Robinson Helicopter Company: Docket No. FAA-2005-21679; Directorate Identifier 2004-SW-33-AD.

Airworthiness Directives; Bell Helicopter Textron Canada Model 206A, A-1, B, B-1, L, L-1, L-3, L-4 Helicopters

ACTION: Notice of proposed rulemaking (NPRM).

Figure 1

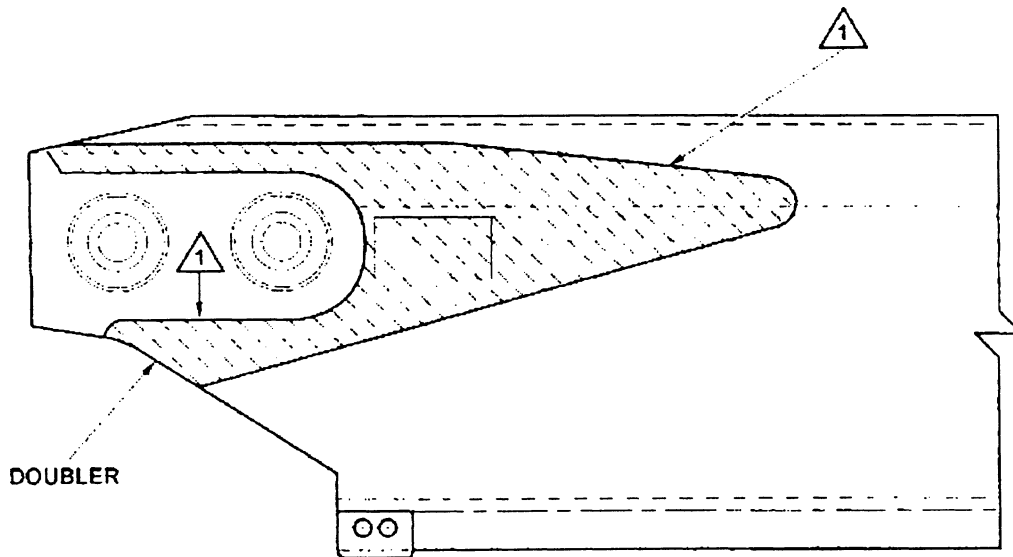
(a) Before the first flight of each day, clean each blade and visually check the blade root doublers for an edge void or de-bond on both sides of each blade as depicted in Figure 1 of this AD. An owner/operator (pilot), holding at least a private pilot certificate, may perform this visual check and must enter compliance with this paragraph into the helicopter maintenance records by following 14 CFR sections 43.11 and 91.417(a)(2)(v).

1 Inspect the doubler for an edge void or de-bond on both sides of each blade.

(b) If an edge void or a de-bond is found, before further flight, replace the blade with an airworthy blade with a serial number other than those to which this AD applies.

(c) Within 100 hours time-in-service, replace all affected, serial-numbered blades with airworthy blades with a serial number other than those to which this AD applies.
